SERVICE BULLETIN

TITLE: ENGINE FUEL AND CONTROL - REPOSITIONING OF FUEL FLOW TRANSMITTERS

Repositioning of the Fuel Flow Transmitter and Shield Installation
Figure 1

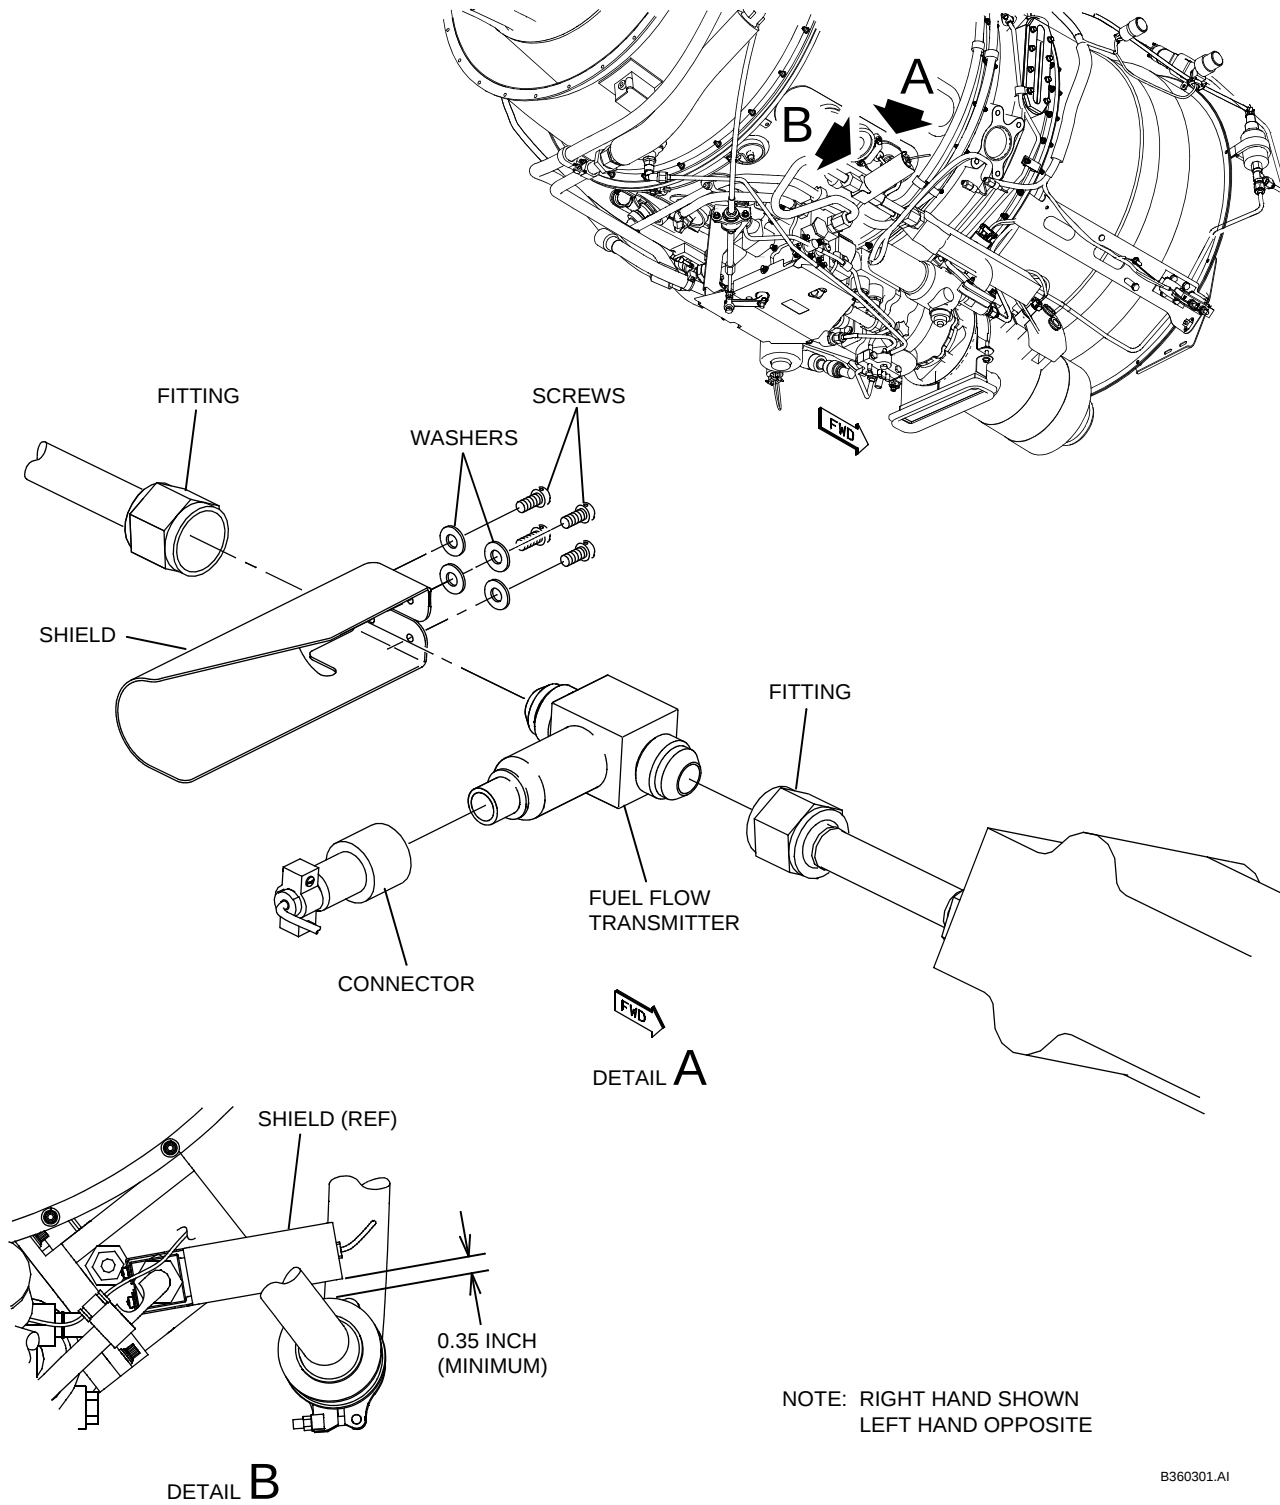
This Service Bulletin is being issued because Raytheon Aircraft Company (RAC) has received reports from the field of intermittent fuel flow indications. The fuel flow transmitters P/N 1/2-1-81-302 were inspected and found to have fuel inside the electrical connector. During engine installation at production, air is purged from the fuel system by temporarily loosening the fuel line connections at the fuel flow transmitter. Any fuel that escapes during this procedure migrates down the body of the fuel flow transmitter and collects in the electrical connector.

This Service Bulletin provides information to reposition the fuel flow transmitter to prevent fuel from collecting in the electrical connector. Instructions are also provided to install a heat shield on the fuel flow transmitter to prevent bleed air heat damage to the fuel flow transmitter.

- (3) Install shield P/N 390-910327-0003 to left and right fuel flow transmitter with four screws P/N MS35275-242 and four washers P/N NAS1149DN832J and secure with safety wire. Refer to Figure 1.
- (4) Install left and right fuel flow transmitters (refer to AMM, Chapter 73-30-01) with the exception that the fuel flow transmitter is rotated up 180° so that the electrical connector is above the bleed air tube. Make sure that there is a minimum gap of 0.35 inch between the fuel flow transmitter shield and the bleed air tube. Refer to Figure 1.
- (5) Reconnect the airplane battery, remove warning notices and restore power.
- (6) Ensure all work areas are clean and clear of tools and miscellaneous items of equipment.
- (7) Return airplane to service.
